RE: SEQRA

Review of Visual Character & Visual
Analysis, Sailor's Cove on the Hudson
City of Kingston
Ulster County, New York

The above image replicates a portion of the simulation for viewpoint 70. The annotation has been added to call out elements of the simulations that are discussed below:

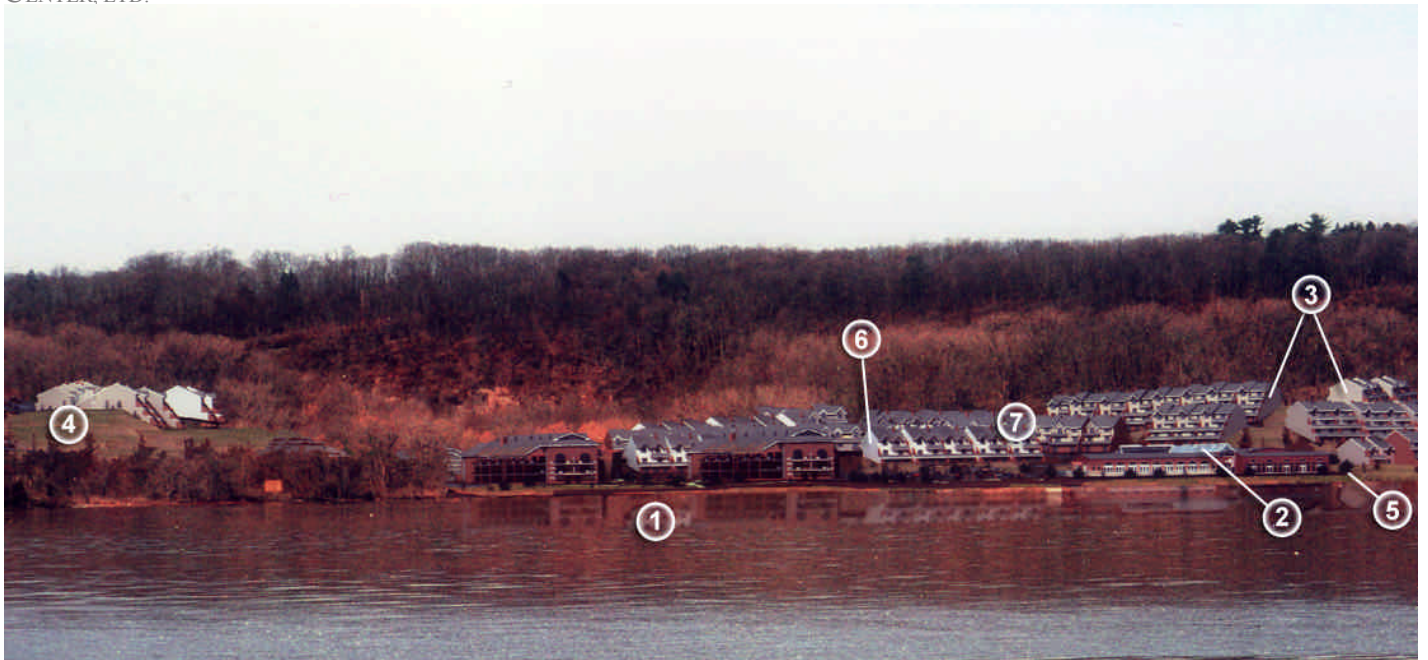
1. The simulation shows the action's reflection off the water.
2. The skylight of the large center building was simulated to show glare / reflected light from certain angles.
3. The photo simulations have a light source correctly depicting the time of day that the photographs were taken. This results in shading that is appropriate to time of day, color of the building and the angle of the action vis-à-vis the viewpoint location.
4. The applicant has placed the buildings of the action on green lawns where appropriate.

5. The trees of the landscape plan are simulated in leaf-off condition at their size at planting, which means they provide very little screening, certainly a worse case condition.
6. The buildings liberally use visible shades (white and light gray) along with brick and tan colors that tend to blend, again ensuring a reasonable worse case simulation.
7. The buildings of the action are simulated with a good deal of architectural articulation, which 1) make the buildings of the action look more realistic, and 2) help the viewer better understand the relationship of the buildings to the surrounding context.

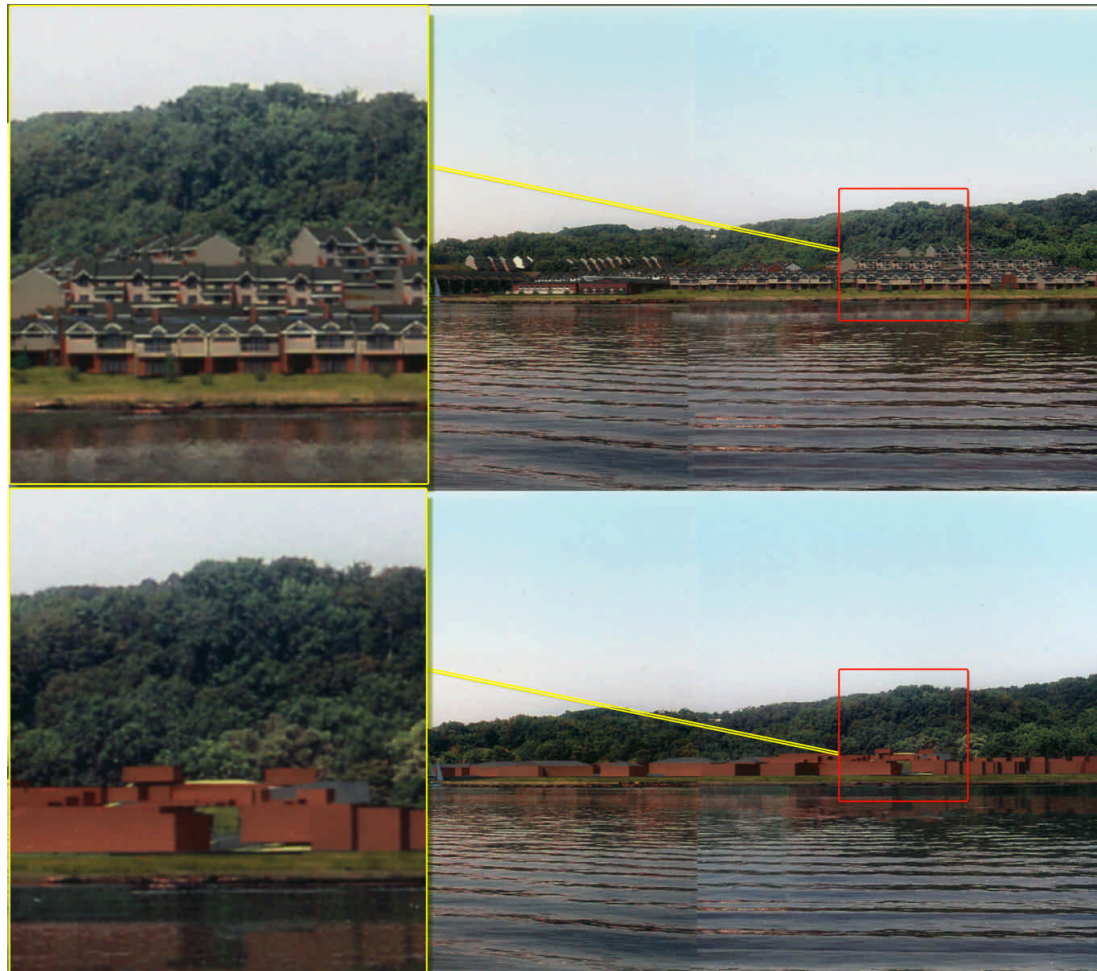
“The earth tone and natural colors of the buildings and roof significantly contribute to reducing the impacts associated with this view. In particular, the colors of the townhouse and condominium units blend the structures into the existing mined landscape.” (pg. 168)

This simulation does not show an action that blends “into the existing mined landscape.” The simulation shows that the action is visually prominent from this viewpoint and the text describing the potential visual impacts from these viewpoints needs to accurately interpret the evidence provided by the photo simulations. Most of the other viewpoints seem to contain text in the Potential Impacts section on page 167 that do not accurately describe the potential impacts shown in the photo simulations. The Potential Impacts section needs to be rewritten with the photo simulations guiding the analysis.
